ADDENDUM NO. 1

FOR: **OZARK COUNTY BRIDGE REPLACEMENT**
BRIDGE 01500251
GRA NO. 13-3136

This addendum is issued due to the change in slab beam dimensions, from 27" to 23". The sheets below have been revised for the 23" beam.

CHECKED BY: SJ
DRAWN BY: KFT
JOB NUMBER: 12-3136
FILE NAME: 12-3136_Structural
SCALE: NTS
ISSUE DATE: 10-03-2013
SHEET NUMBER: S5

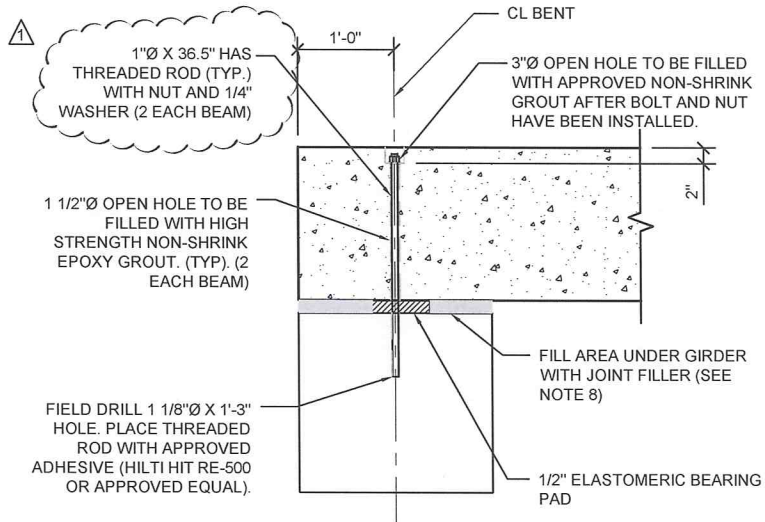
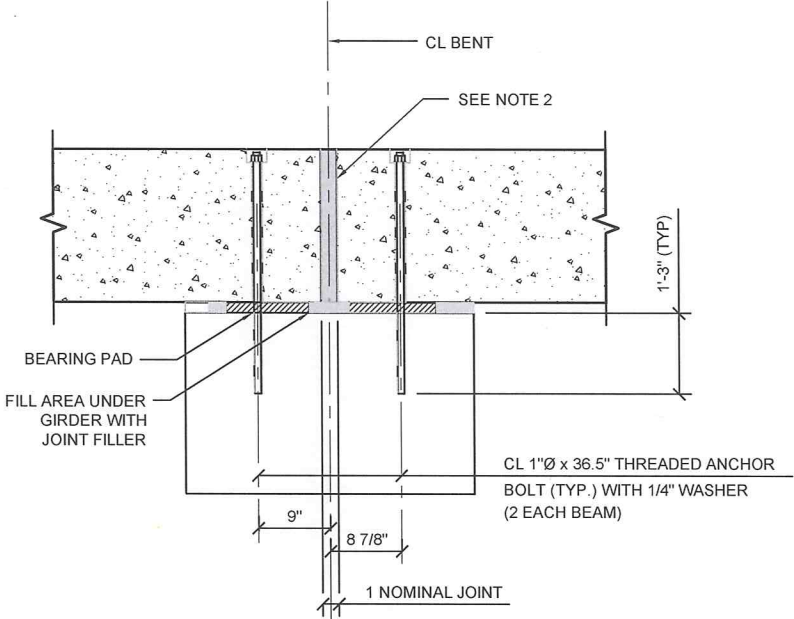
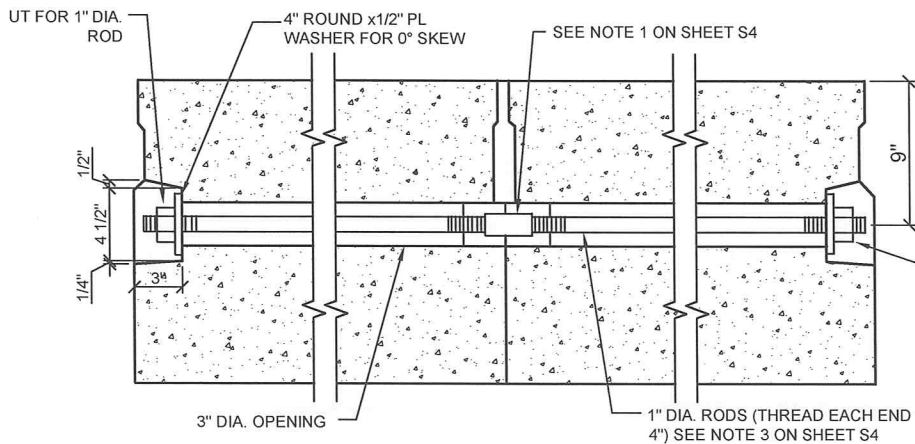
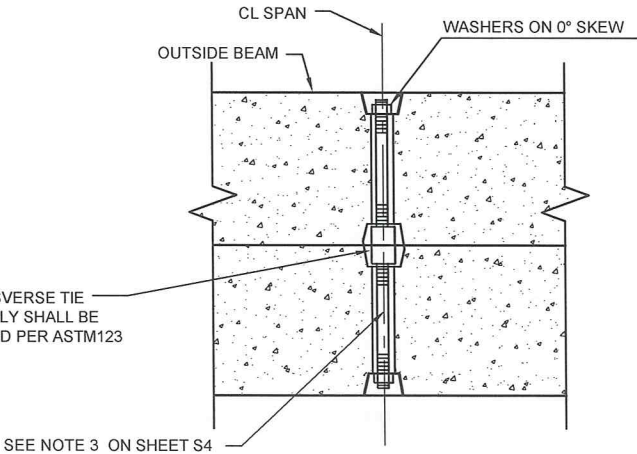
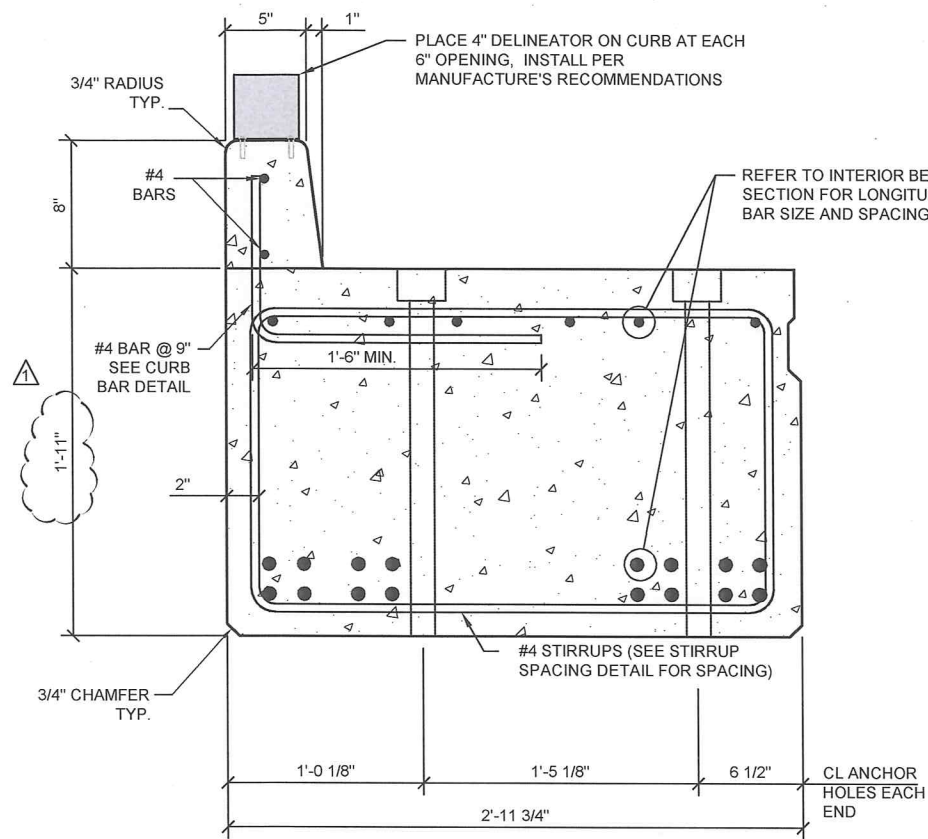
On the Construction Plans sheet S5, threaded rod has changed.

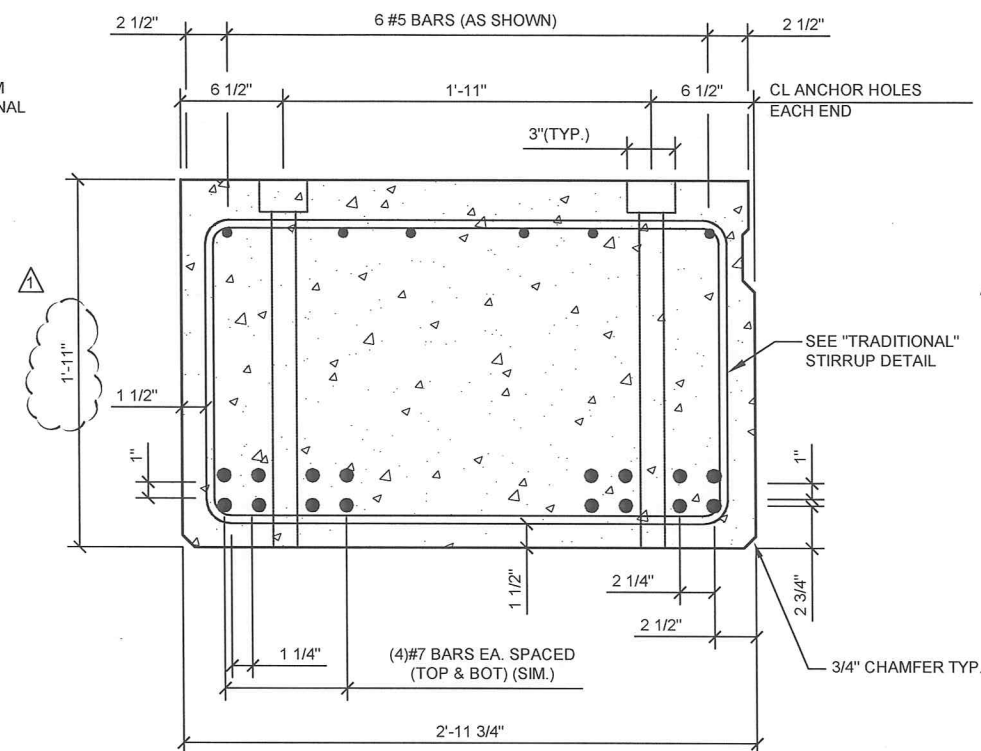
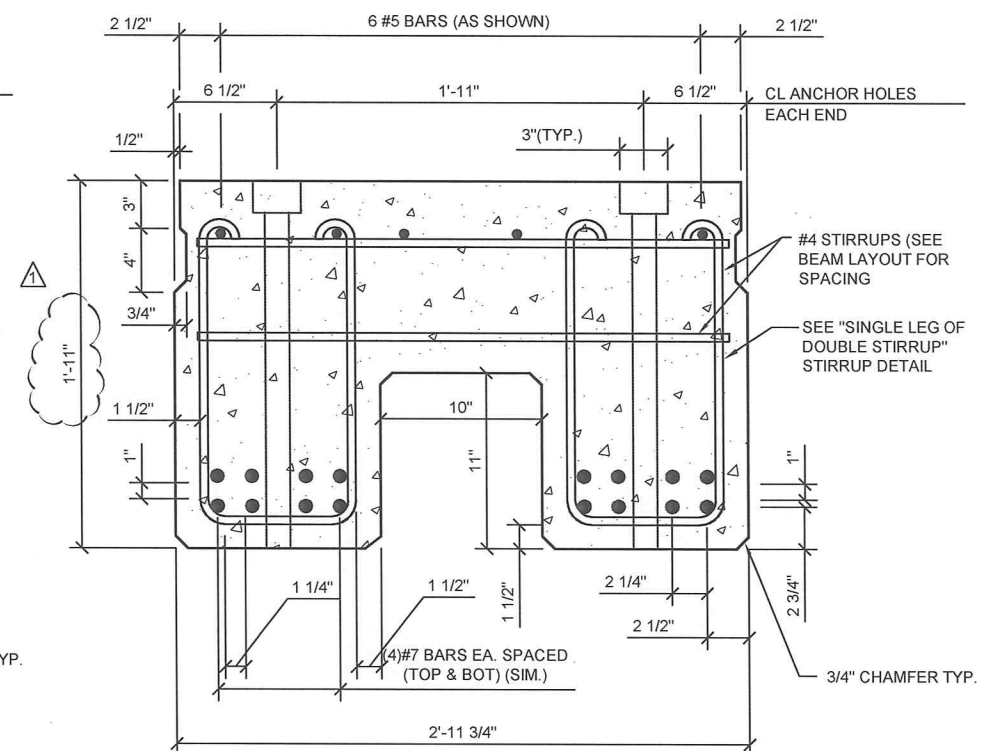
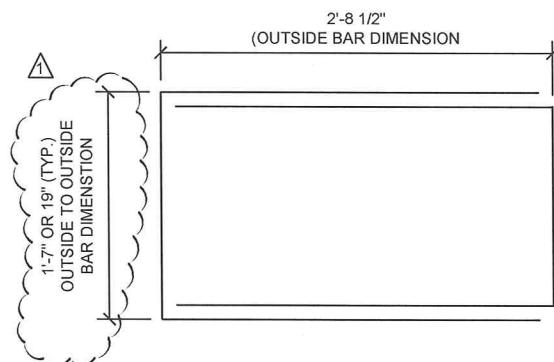
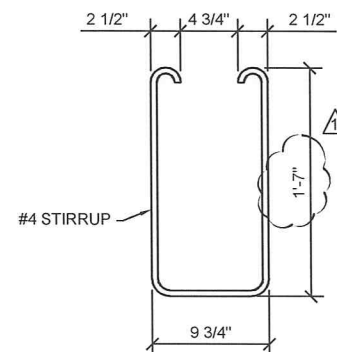
On the Construction Plans sheet S6, the dimension of the slab beam have changed to 1'-11" and stirrup dimensions have changed.
